# PERMIT

**SEWAGE DISPOSAL SYSTEM**  
HOWARD COUNTY HEALTH DEPARTMENT  
BUREAU OF ENVIRONMENTAL HEALTH  
410-313-2640

SUBDIVISION Carriage Mill Estates LOT NUMBER 56 ADDRESS 14780 Carriage Mill Drive

Approved Septic System Plan  
Howard County Health Department

**TRENCH DATA**

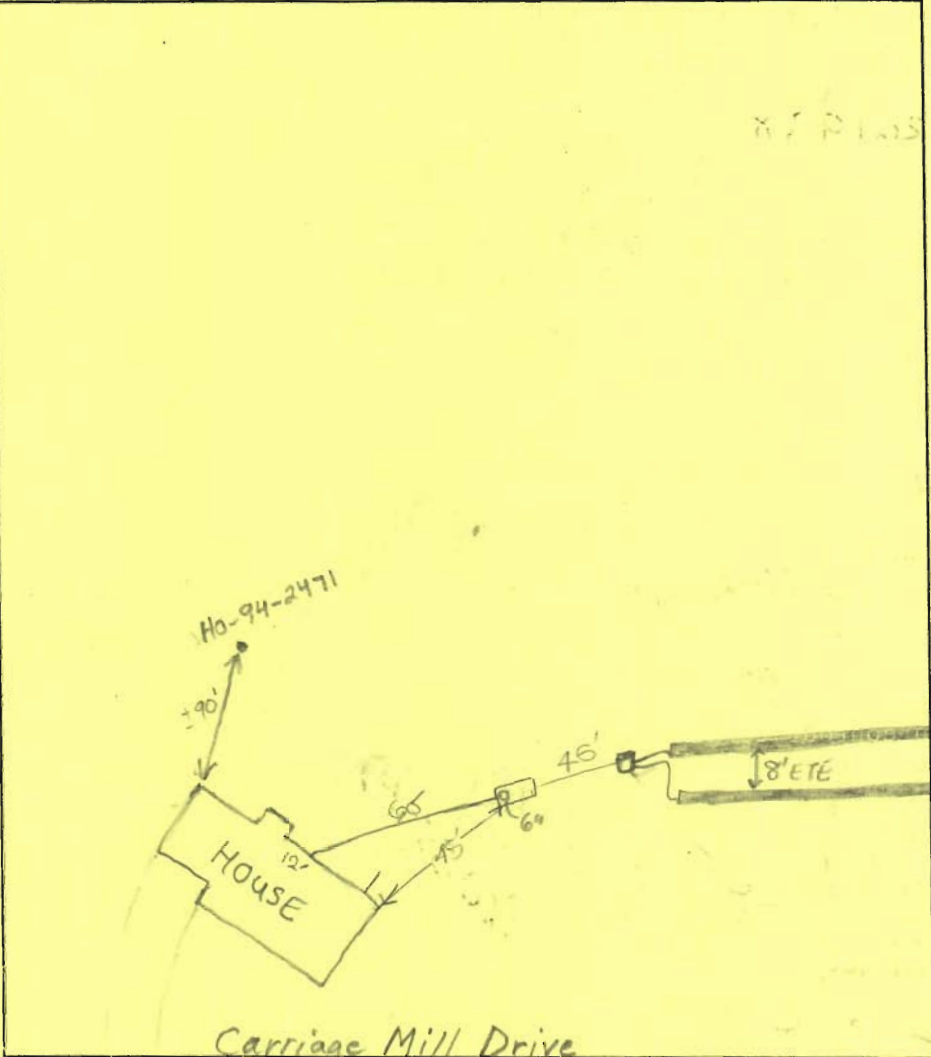
INSPECTION COMMENTS: 8/29/00 Perc test requested by contractor to be rescheduled. BB  
9/14/00 SPECS ADJUSTED TO 210' BR; TOTAL REQ'D = 210'; OK  
FOR (2) 105' TRENCHES (MR)  
9/14/00 P.M. OK to cover from house to dist box. Need  
manhole cleanout on septic tank. OK to continue. DVG  
9/26/00 NO ONE PRESENT, NO ADD'L WORK (MR) 9/29/00 D.H. D.Box Hole Full w/ water, Material by pm 11.  
9/29/00 - OK TO COVER ALL WORK (SRW)

TRENCH WIDTH 2'  
 TRENCH INLET DEPTH 4.5'  
 TRENCH BOTTOM DEPTH 8.5'  
 DEPTH OF STONE 4'  
 NUMBER OF TRENCHES 2  
 TOTAL TRENCH LENGTH 210'  
 ABSORBENT AREA 840ft<sup>2</sup>  
 DISTRIBUTION BOX LEVEL   
 BAFFLE IN DISTRIBUTION BOX

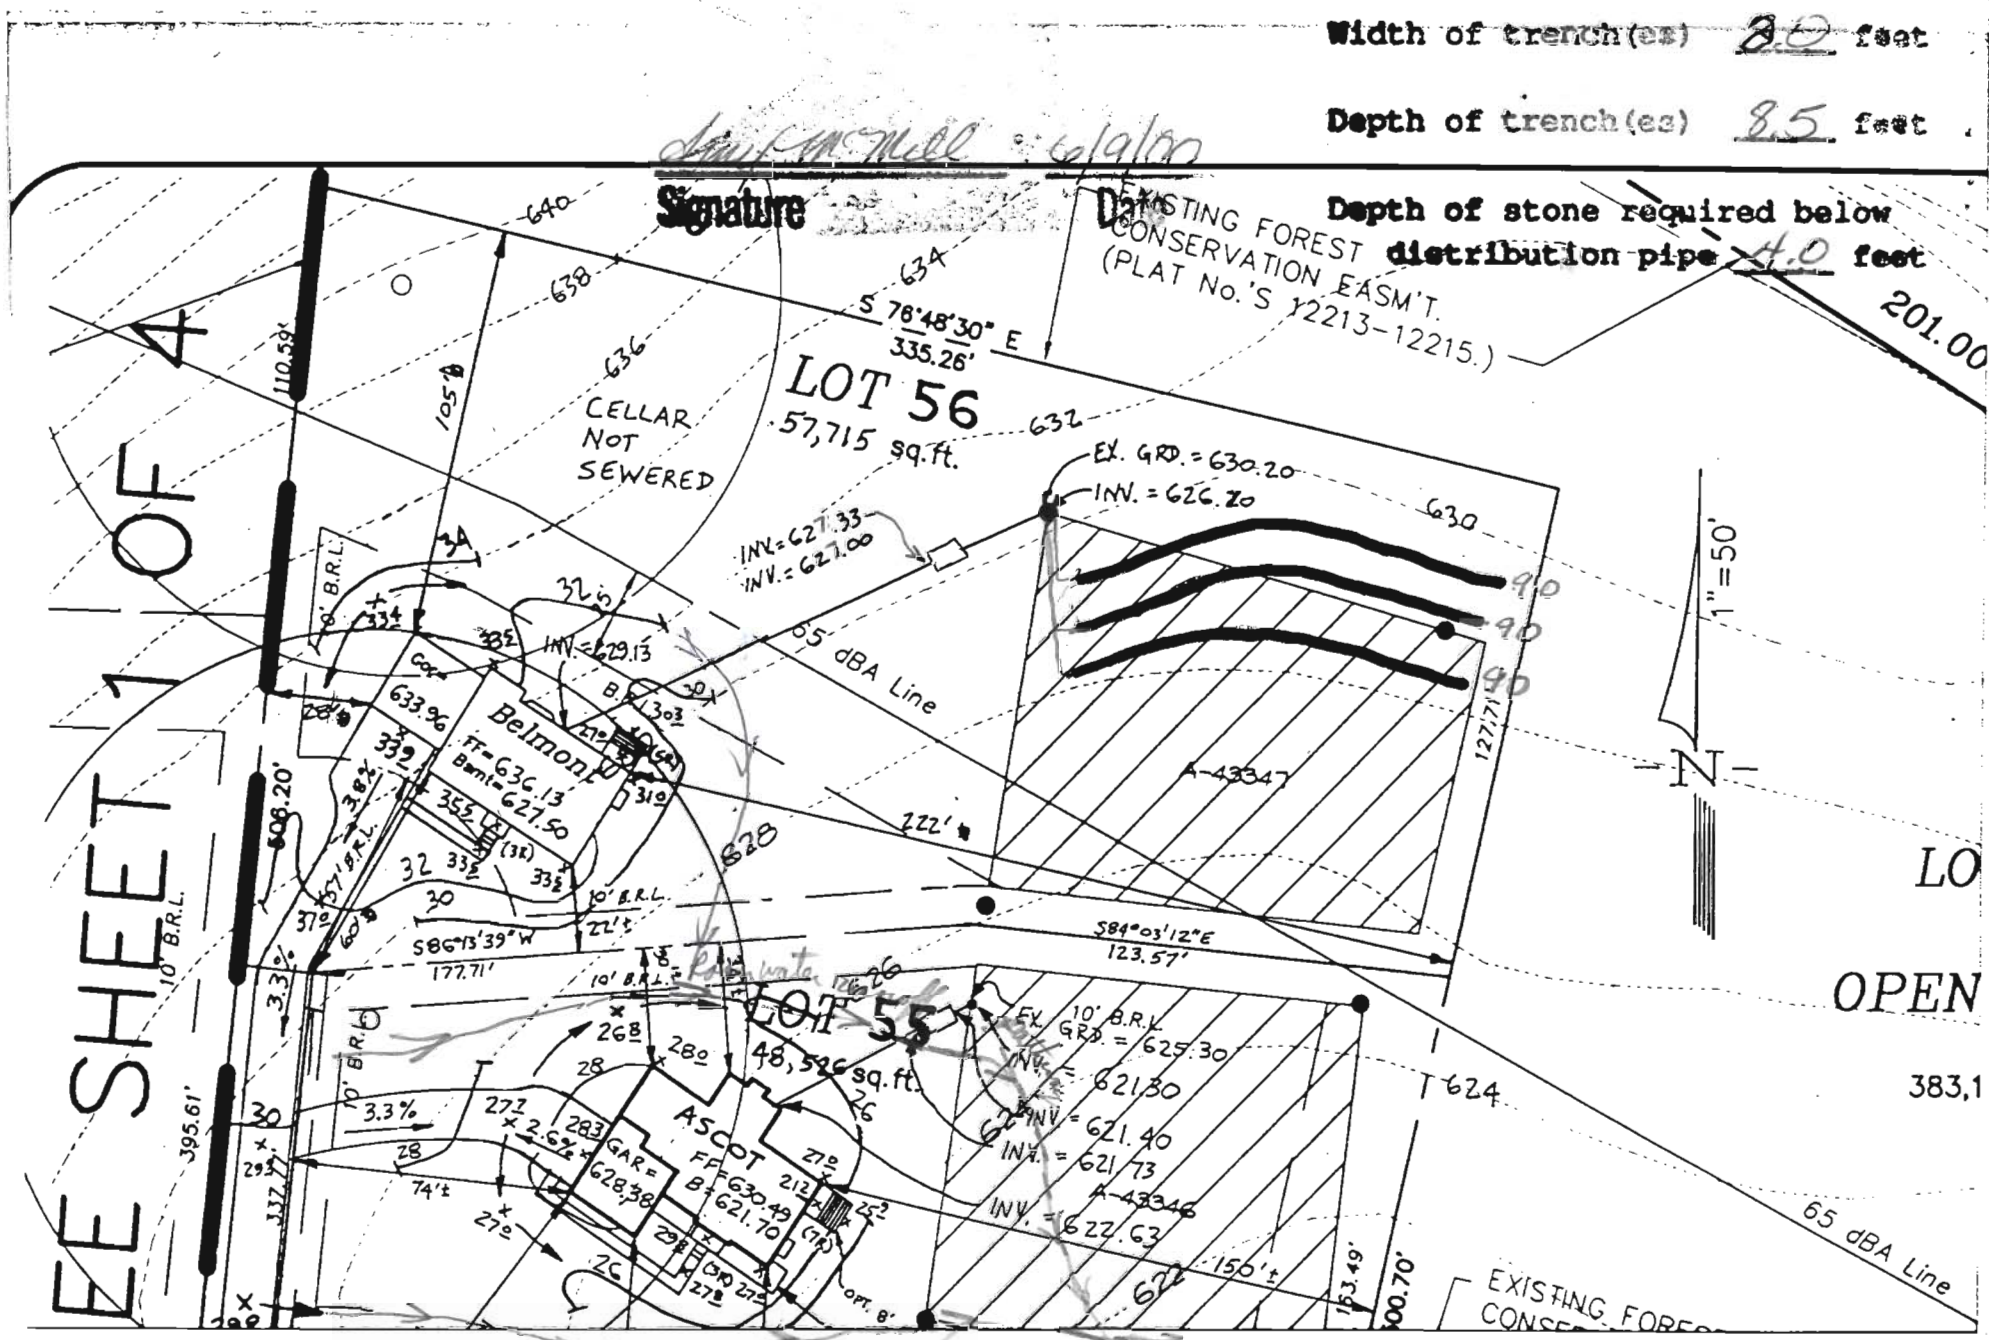
Total linear feet of trench 270  
required ~~220~~ feet
